DOC21/968110 MP08_0150-PA-46

Bulli Seam Operations - Appin Mine LWs 709-711 and 905 Extraction Plan (MP08_0150-PA-46) – post approval assessment

Figure 1. Location of landholder bores and South32 monitoring bores for the Longwalls 709 to 711 and 905 Extraction Plan. Note the lack of any monitored bores in pools, alluvium or hard rock aquifers directly above the longwalls.

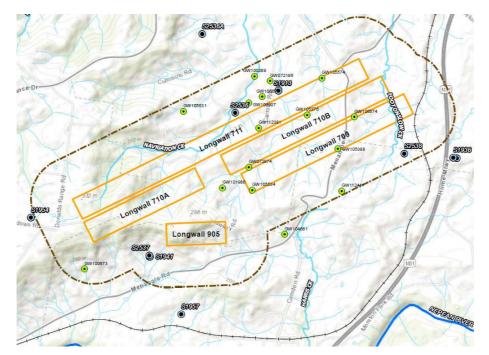
- There are no locations where water levels in **pools**, **alluvium or hard rock aquifers** are monitored directly above the proposed longwalls (see Figure 1).

- Many of hard rock piezometers are already impacted or are not recording at all.
- The majority of bores close to the extraction area do not have an appropriate baseline to assess change¹.

- The quality of the data is considered highly suspect for some piezometers².
- SLR (2021a) predicted 3m and 4m depressurisation of landholder bores GW072874 and GW105534 in the lower HBSS due to mining at Longwalls 709 to 711 and 905. These bores are not instrumented/monitored and nor are landholder bores GW101986, GW105388, GW106574, GW105376, GW112381 and GW105574 (likely to experience similar drawdown to that of GW105534).

The surface water and groundwater monitoring program that is currently in place is poor and insufficient to assess the surface water and groundwater impacts of the proposed Longwalls 709 to 711 and 905 Extraction Plan; or whether performance measures under the approval are met.

- A proper Before-After-Reference-Impact (BACI) design that:
 - monitors surface water level in permanent (or near-permanent) pools in the third order sections of Navigation Creek, Navigation Creek Tributary 1 and Foot Onslow Creek where they are directly undermined by the longwalls

- monitors water levels in the alluvium of the third order sections of Navigation Creek, Navigation Creek Tributary 1 and Foot Onslow Creek where they are directly undermined by the longwalls

- monitors groundwater levels in deeper bores so that there is adequate baseline established and an adequate assessment of impact on groundwater aquifer levels can be achieved.

- water level sensors in a range of permanent (or near-permanent) pools in the third order sections of Navigation Creek, Navigation Creek Tributary 1 and Foot Onslow Creek above the longwalls and monitor pool levels on a daily basis, and

- a range of piezometers and water level sensors in the alluvium of the third order sections of Navigation Creek, Navigation Creek Tributary 1 and Foot Onslow Creek above the longwalls and monitor alluvial aquifer levels on a daily basis

additional groundwater bores in the vicinity of the proposed longwalls that have adequate baseline data and functional recorders with monitoring of aquifer levels on a daily basis.
